## Braid Road SfP / Quiet Route Stakeholder Feedback

Thank you for the invitation to comment on the detailed designs. We welcome the additional detail and look forward to seeing the Southern end of the Quiet Route established.

Please see below specific matters that Spokes SE members believe need consideration prior to implementation;

- **MQR-C-GA-00-00-01: MQR Overview**
  - This overview should indicate both the proposed motor vehicle traffic routes being facilitated by the reopening and the proposed Quiet Route. Spokes SE believes that there will be through traffic on most sections of the QR contrary to the name.

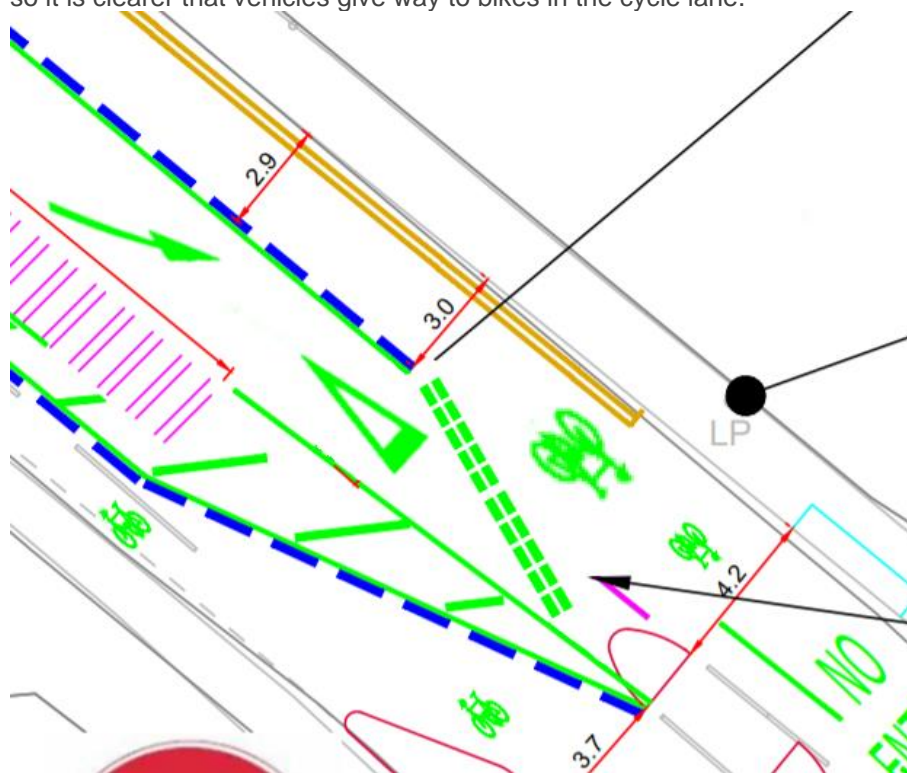
- It should be noted that as well as cyclists on the MGB Quiet Route, there will be cyclists heading and returning from North East destinations such as Blackford Pond via Midmar Dr. and on Braid Rd to and from Morningside station. Where do they fit into the plan?

- We welcome the fact that efforts have been made in the plan to contain most south and northeast bound traffic in Hermitage Drive/ Midmar, but Midmar presents a number of problems (lack of traffic lights to control Northbound, junction at Midmar Drive and corner at the south end), we wonder if Braid Avenue wouldn't have been more suitable for the sort of traffic flow, being wide, straight, and light-controlled.

- It is difficult to safely separate cars and cyclists at the 4-way junction at the East end of Braidburn Terrace (previously a mini roundabout) with a single modal filter such as proposed. We recommend that until a better solution can be found Braid Burn Terrace should be temporarily closed to all traffic except walking wheeling cycling.
